October 12, 2000 GO2-00-178

Subject: WNP-2 OPERATING LICENSE NPF-21 REQUEST FOR AMENDMENT FACILITY NAME CHANGE

Pursuant to 10 CFR 50.90, this letter transmits a request to amend facility Operating License (OL) NPF-21 to reflect the facility name change from WNP-2 to Columbia Generating Station. In addition, this request includes editorial changes to Technical Specification Figure 4.1-1, Site Area Boundary.

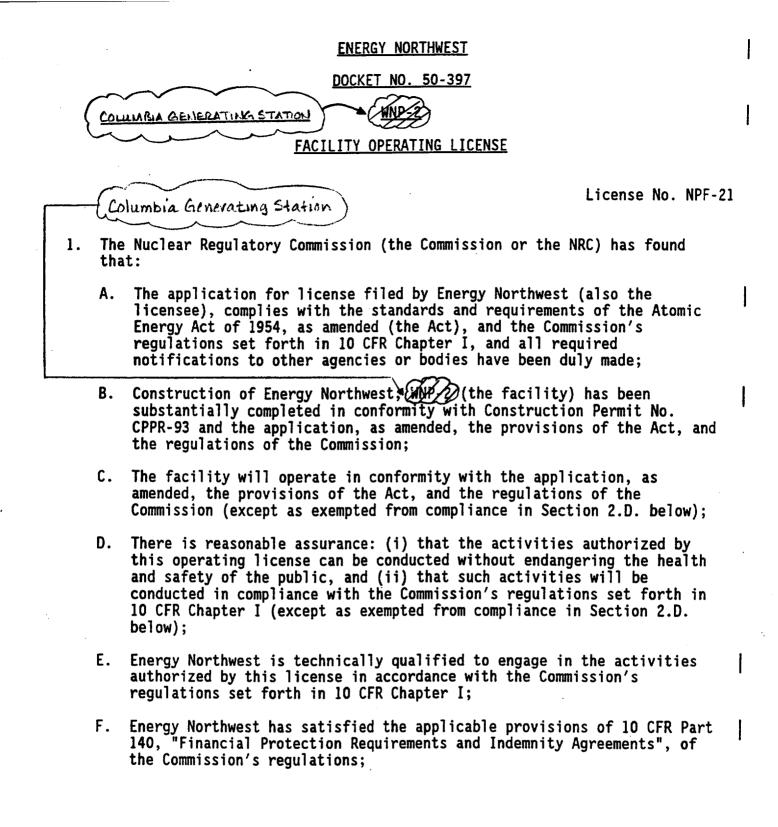
With this submittal, the NRC is being requested to change references to the facility name from WNP-2 to Columbia Generating Station in all applicable locations of the Operating License (OL). This request also applies to Appendix A (Technical Specifications) and Appendix B (Environmental Protection Plan) of the OL. In addition, the proposed change includes the following editorial changes to Technical Specification Figure 4.1-1, Site Area Boundary:

- changing WNP-1&4 PUMP HOUSE and WNP-2 PUMP HOUSE to River Pump Houses,
- Deleting PLANT SUPPORT FACILITY
- Deleting WNP-2 from WNP-2 ACCESS ROAD TO ROUTE 4.
